SERVICE BULLETIN

SB240F

INSPECTION OF PROPELLER BLADES FOR CRACKING

1A170E/JHA[XXXX], See Compliance: for Specific Serial

Figure 1. (Sheet 1)

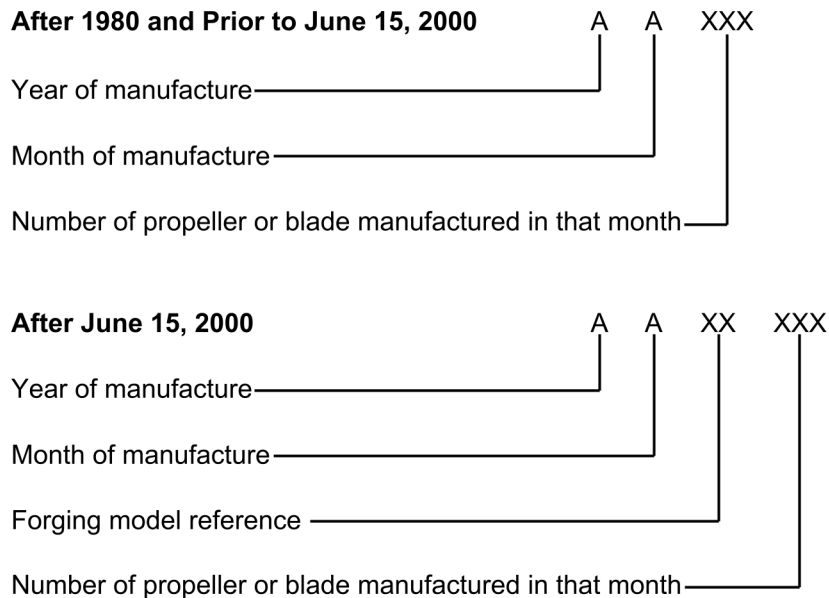
NOTE: Refer to Figure 1 for serial number explanation.

NOTE: Refer to Figure 1, Sheet 1 for serial number explanation.

As of June 15, 2000, McCauley has revised the serial number stamping system on blades and fixed pitch propellers. The first letter remains the year of manufacture, the second letter remains the month of manufacture, the next two digits will reference the forging model, and the last three digits reference the number of propeller or blades manufactured in that month.

Figure 2. (Sheet 1)

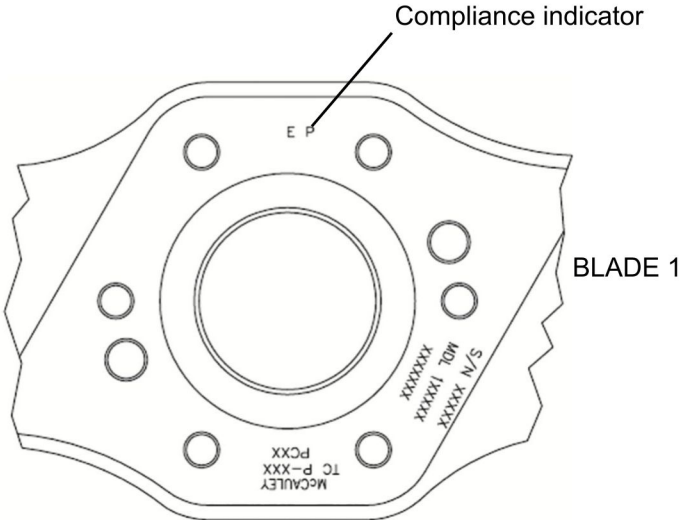
- (7) (Refer to Figure 2, Sheet 1.) Stamp propeller hub with compliance indicator "P" at initial inspection using 0.125 inch (3.18 mm) round bottom steel stamp. Stamp the applicable number after the letter "P" to indicate ("2") and additional ("3", "4" etc.) inspections. Compliance indicator is to be stamped 180° from "McCauley" stamping. The propeller may have previous compliance indicator "E" stamped on the hub, stamp new indicator after "E", if present.
